Introduction

This errata sheet provides updated information on Stratix® II GX devices. This document addresses known device issues and includes methods to work around the issues.

Stratix II GX Device Family Issues

Figure 1. Rate Matcher Duplicating $\|S\|$ Column

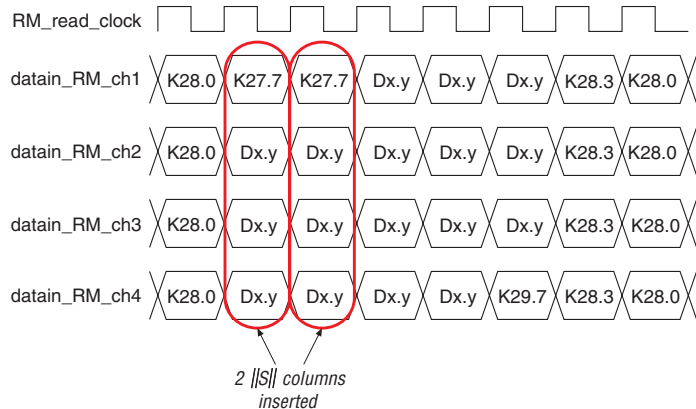
In the XAU1 operating mode, the Stratix II GX rate matcher might insert a duplicate Start Column (||S||), causing corruption of the data packet.

When the rate matcher has to insert $\|R\|$ for clock rate compensation, there are instances where the rate matcher inserts a duplicate $\|S\|$. This duplication causes packet corruption. The duplication of $\|S\|$ happens only when the rate matcher block's insertion logic has to insert multiple $\|R\|$ columns before the $\|S\|$ column. This is shown in [Figure 1](#).

Altera has implemented a solution for this issue in the Quartus II software version 7.1.

If you have implemented a Stratix II GX XAUI design in versions prior to the Quartus II software version 7.1, recompile your design in the Quartus II software version 7.1.

Figure 2. Illegal Insertion of /R/ Characters After the Start of Packet (SOP)

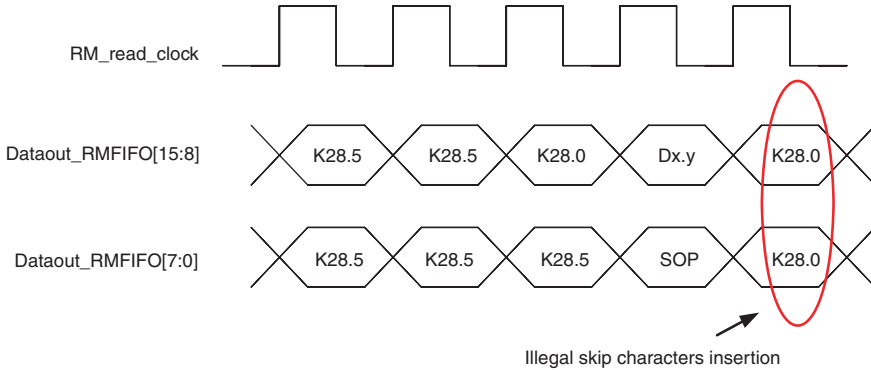
In Basic double-width mode, the Stratix II GX rate matcher may insert skip characters after the start of packet under certain conditions, as explained below. This causes corruption of the data packet.

- if the rate matcher has to insert skip characters for clock compensation **AND**
- the control and the skip characters are received in the lower and upper byte of the data stream, respectively, immediately before the start of packet (SOP)

Figure 2 shows an example of illegal insertion with /K28.0/ and /K28.5/ programmed as skip and control characters, respectively.

Figure 3. Parallel Data Sent from Transmitter

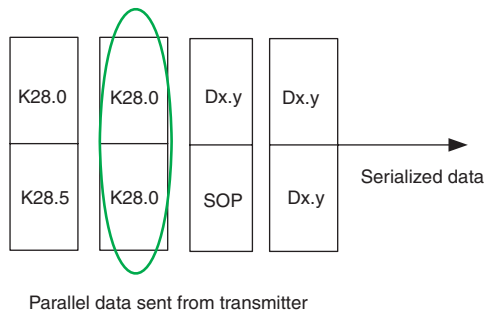
If the protocol on the upstream transmitter can be modified to send a column of skip characters immediately before the start of packet, the issue will not happen (as shown in Figure 3).
